P 06395

SEWAGE DISPOSAL SYSTEM

MARYLAND STATE DEPARTMENT OF HEALTH

HOWARD COUNTY

INDICATE NORTH. - NAME ADJOINING ROADWAY AS BASE LINE.

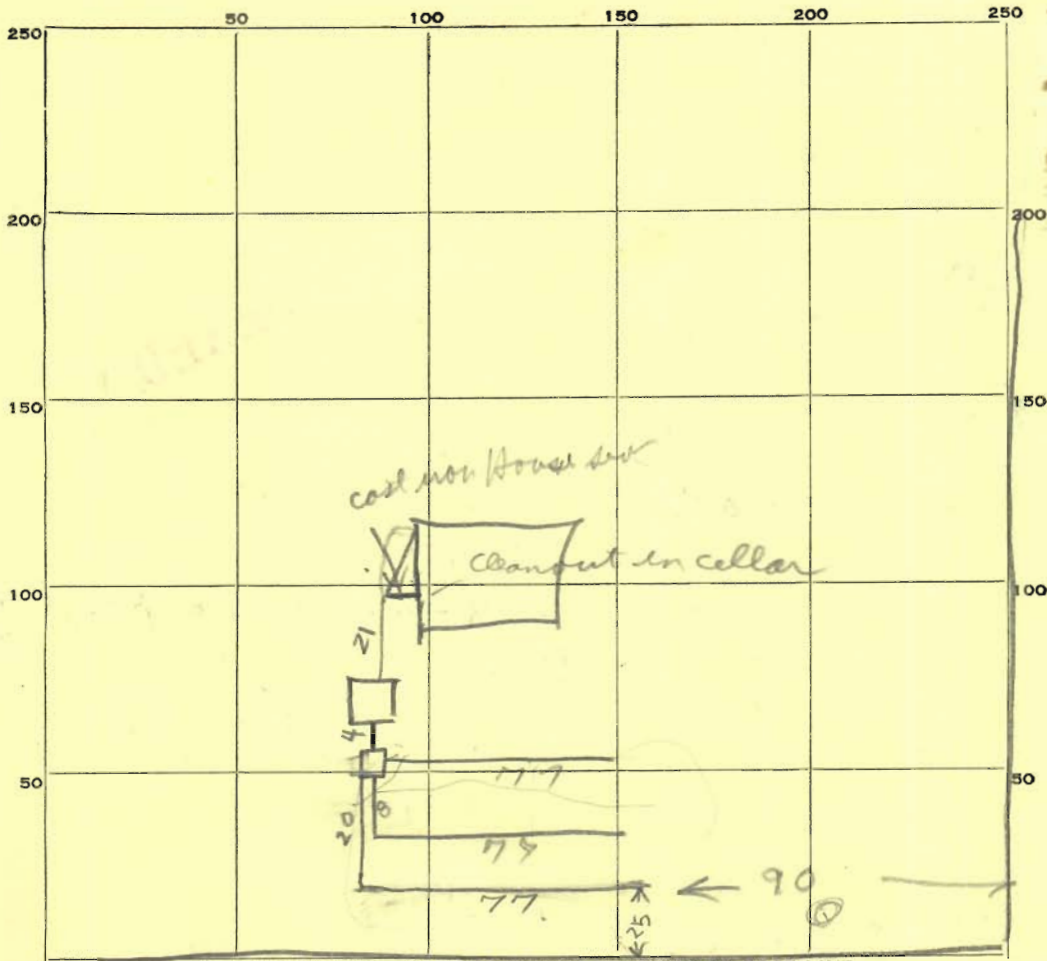
No cleanout

28 May 63 3 bedrooms - 3 x 154 = 462 sq ft required
OK to cover tile field but septic tank must be re-inspected
for ① cleanout ② inlet tee ③ house sewer R/W

Place the tilefield about 160 to 180 ft. from the sideline of the lot farthest from Rt 216 and 25 to 55 ft. from Line Kelp Rd.
